SERVICE INSTRUCTION M20-112 (Rev. A)

Date: December 19, 2007

- SUBJECT:** TO ADVISE OWNERS OF THE RETROFIT KIT 940164-501 FOR DUKES ACTUATOR PART NUMBERS: 4196-00-1 AND DIRECT REPLACEMENT FOR DUKES1057-00-5G. THE RETROFIT KIT 940164-503 FOR THE ITT ACTUATOR P/N's LA11C2110 (MAC 950227-501) and ITT actuators LA11C2114, LA11C2115.

**FIGURE 1 - SEPARATING DUKES ACTUATOR GEAR AND MOTOR HOUSING
(4196-00-1C - SHOWN)**

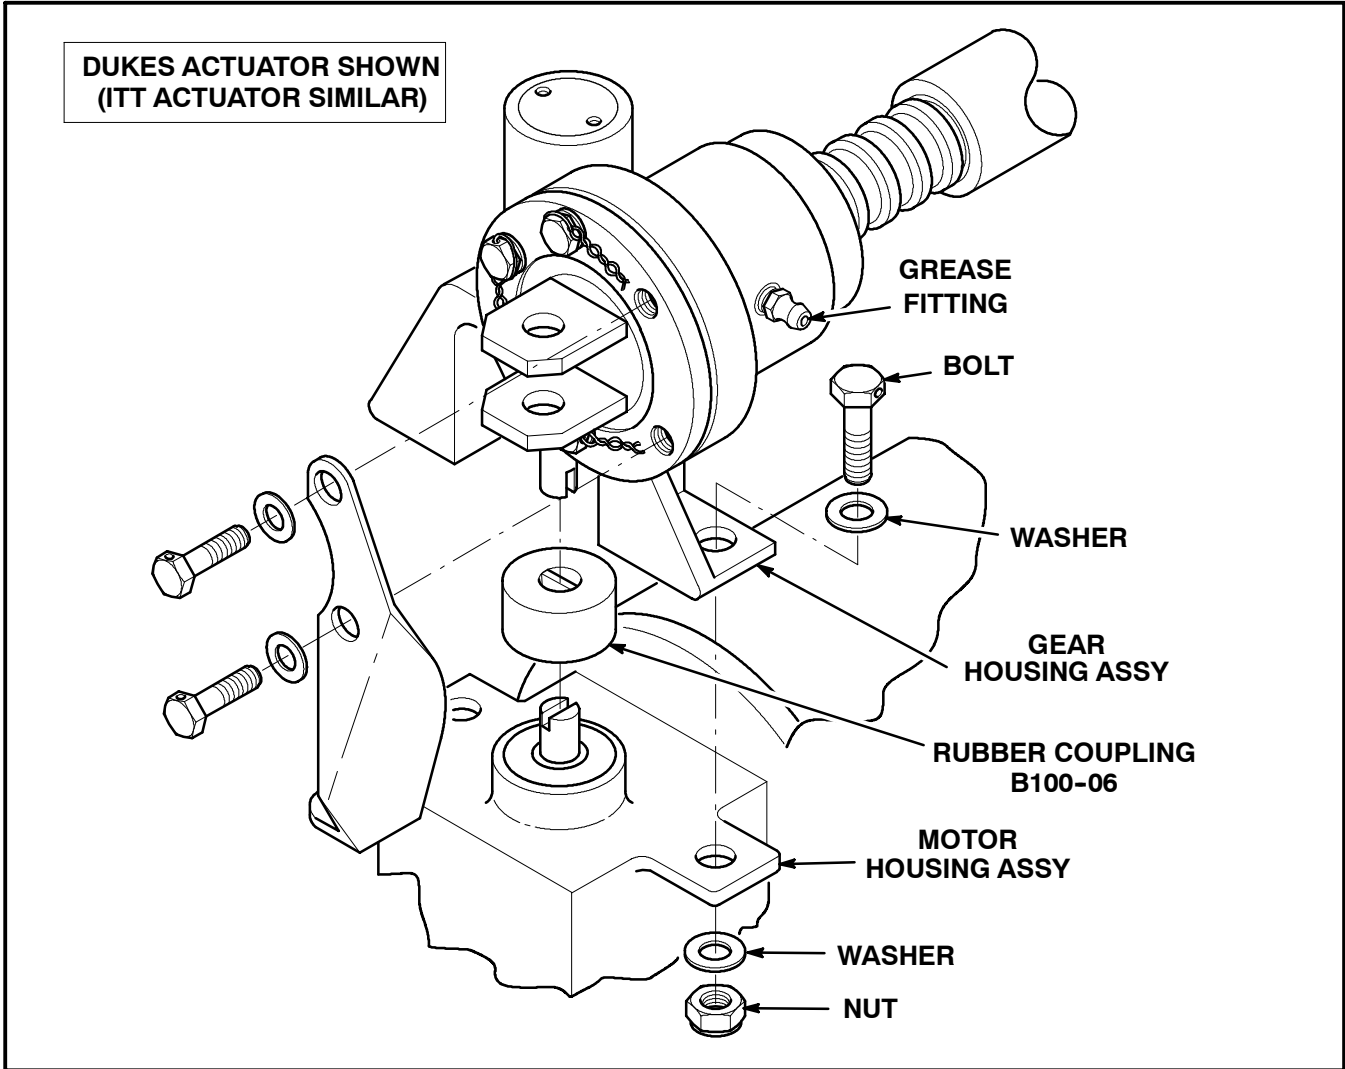
2. Separate motor/gear housing by removing the two nuts/washers/bolts from the brackets holding motor/gearbox assembly to the jackscrew/gearbox assembly. (See Figure 1)

FIGURE 2 - DUKES ACTUATOR EXPLODED VIEW (4196-00-1C - SHOWN)

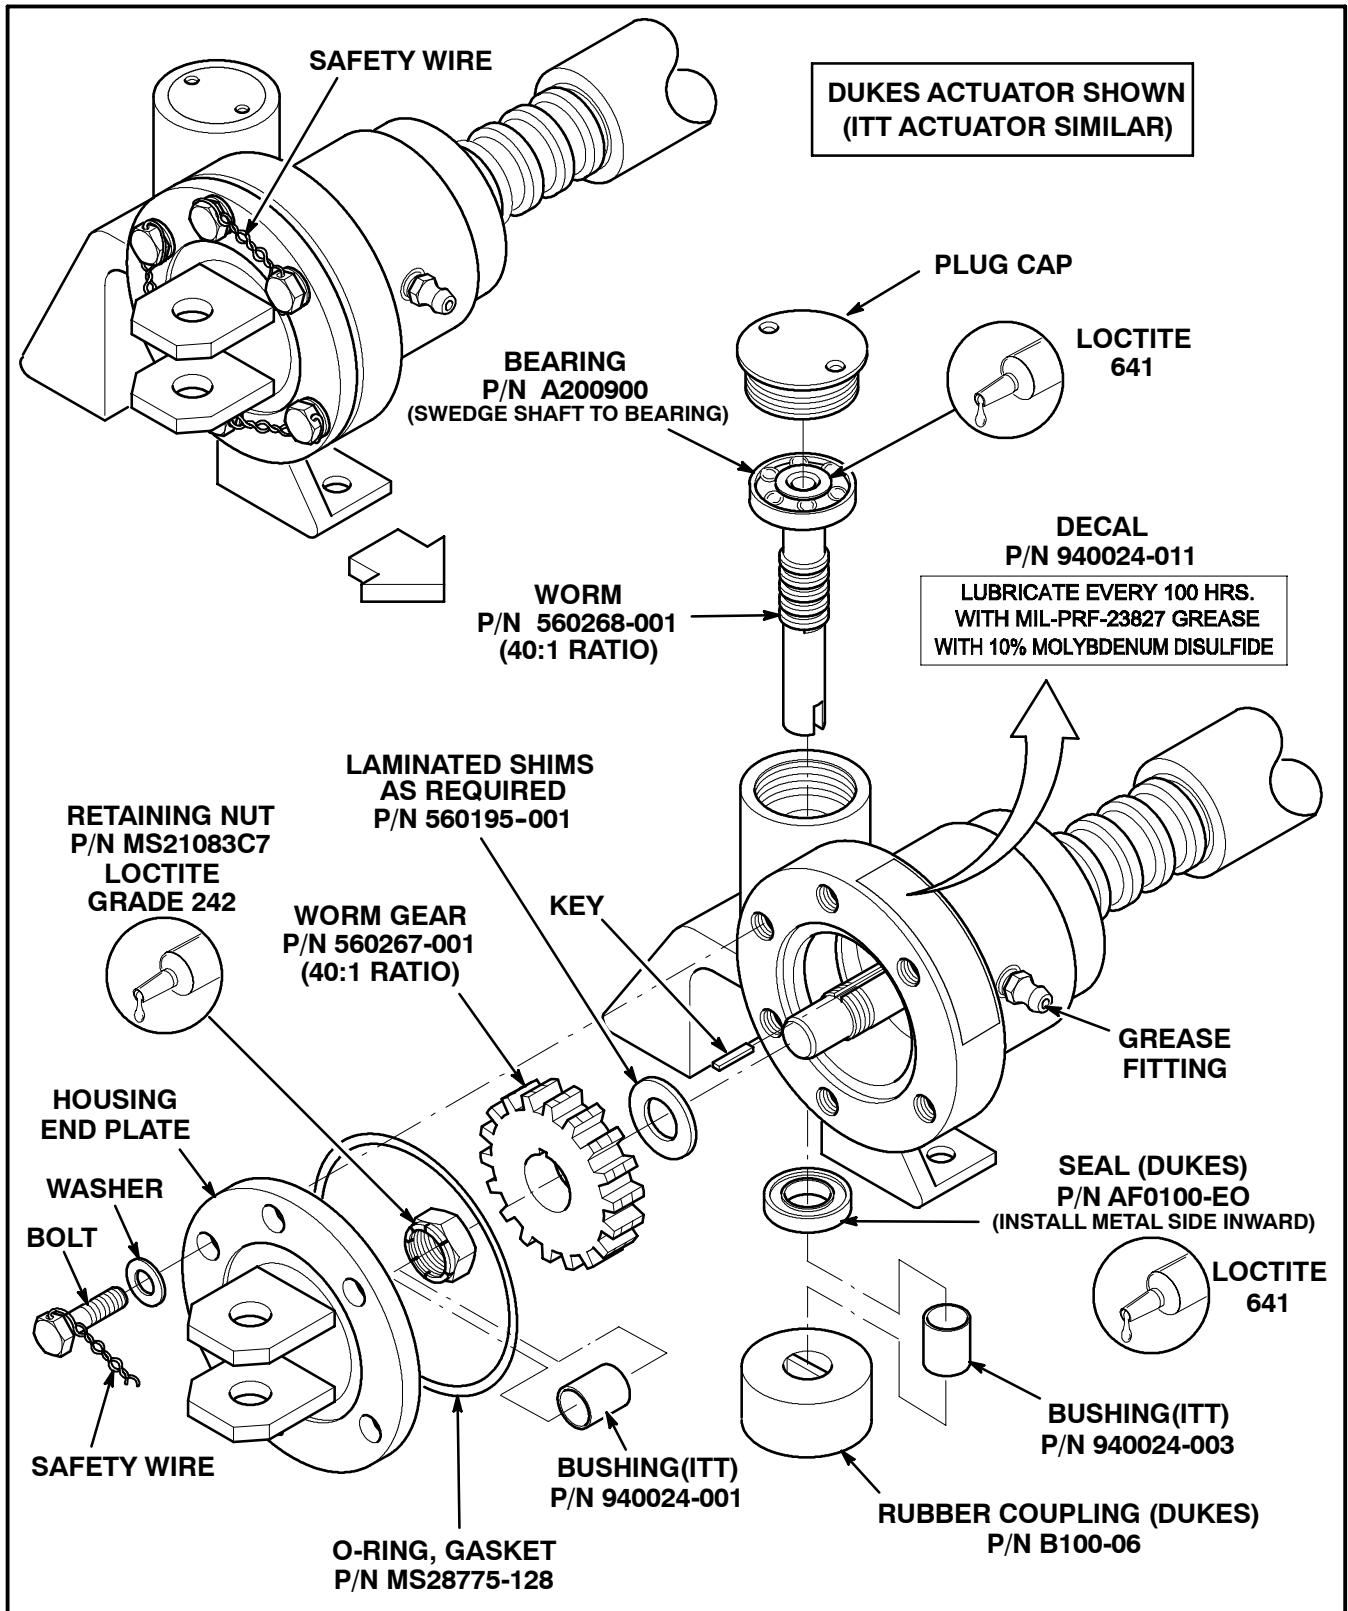
10. Install new parts from Retrofit kit in reverse order:
 - 940164-501 kit – Dukes 4196-00-1 (MAC 950158-503)
 - 940164-503 kit – ITT LA11C2110 (MAC 950227-501) and LA11C2114, LA11C2115
11. Install new bushing 940024-003 into housing (ITT) or apply Loctite™ 641 to new lower seal AF0100-EO (Dukes) and install into housing assembly, metal side inward until flush with housing (See Figure 2).

FIGURE 3 - DUKES ACTUATOR - SECTION VIEW (4196-00-1C - SHOWN)

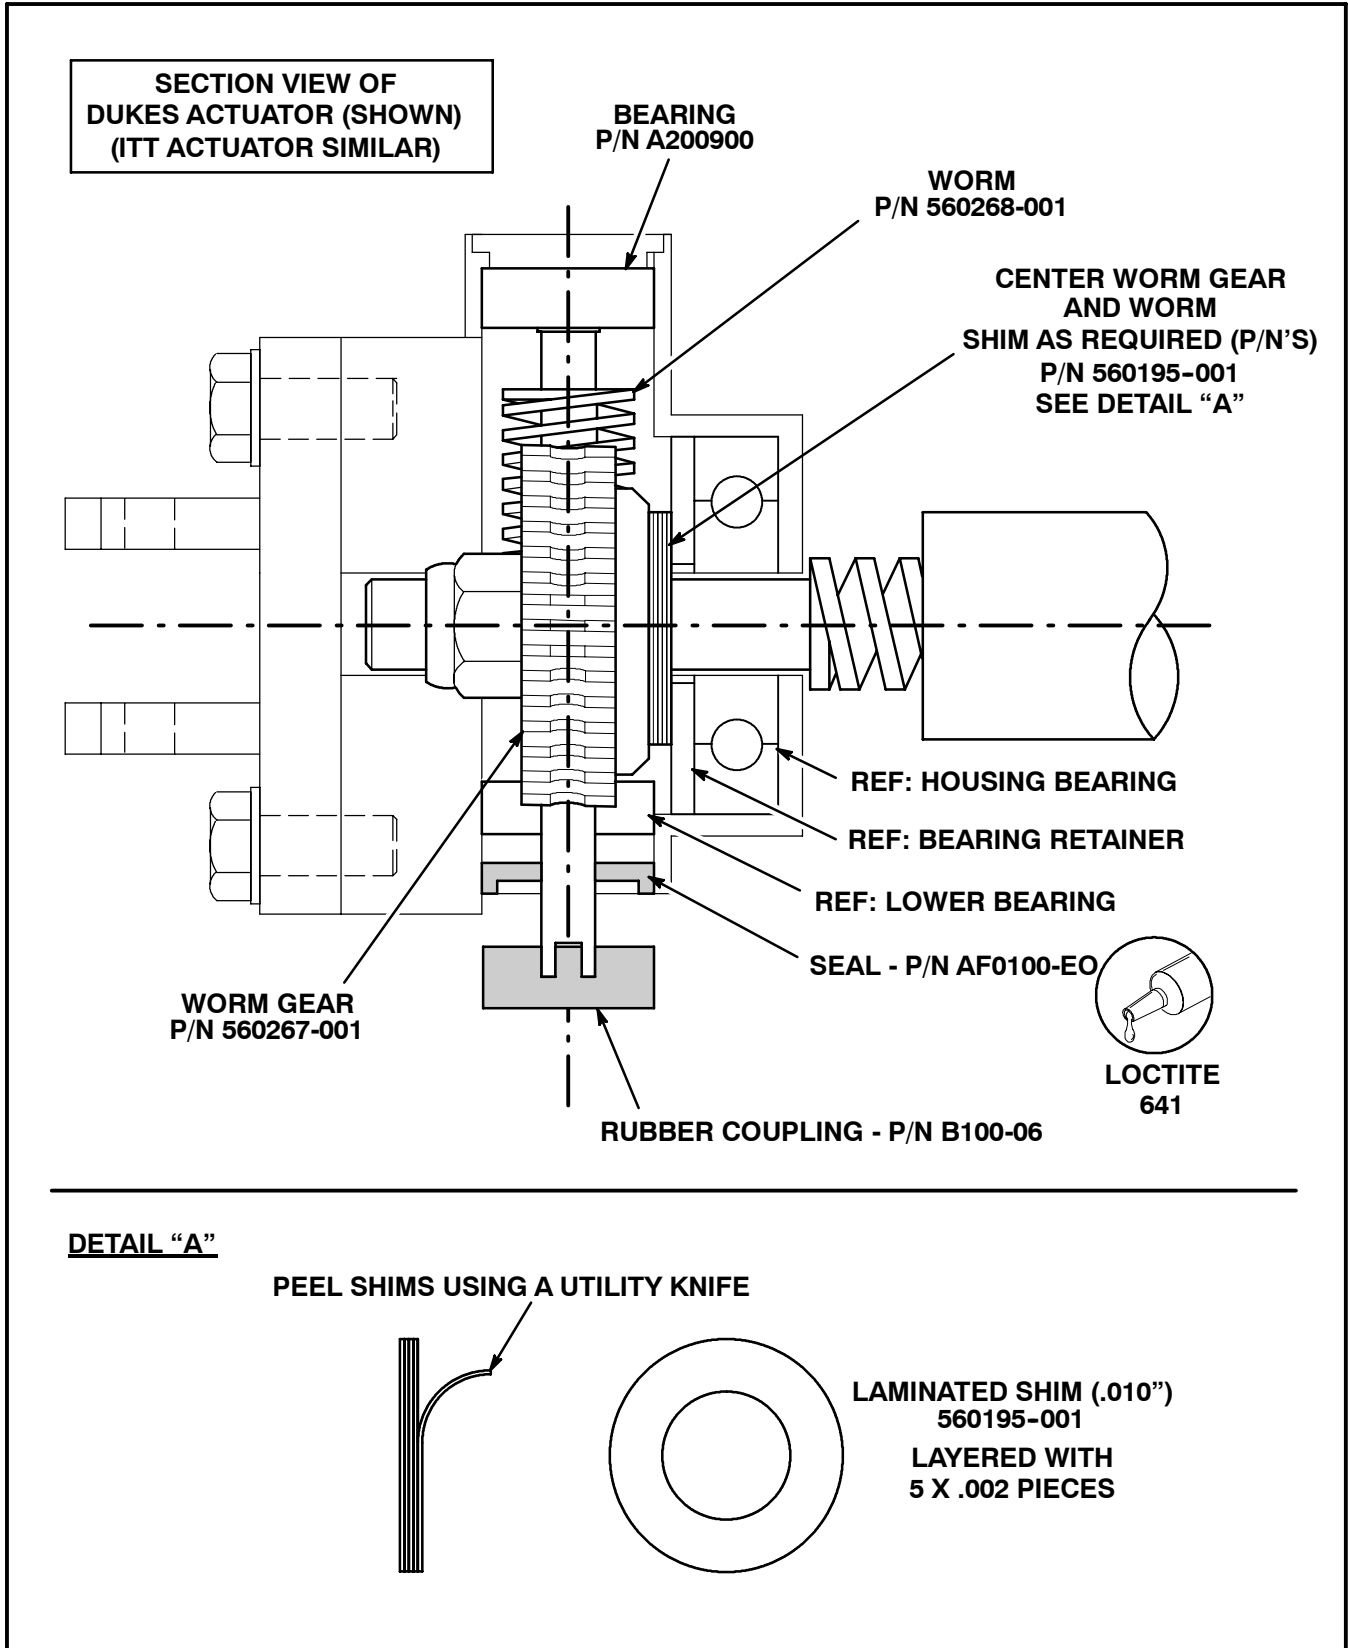
15. Check worm gear so it engages with center of worm without binding or catching. Use laminated shim washer(s) 560195-001 provided in kit to properly align worm gear. These shims are made laminated to a .010” total thickness (made from 5 pieces of .002” material) and can be separated by using a utility knife to achieve proper thickness for alignment. (see Figure 3)
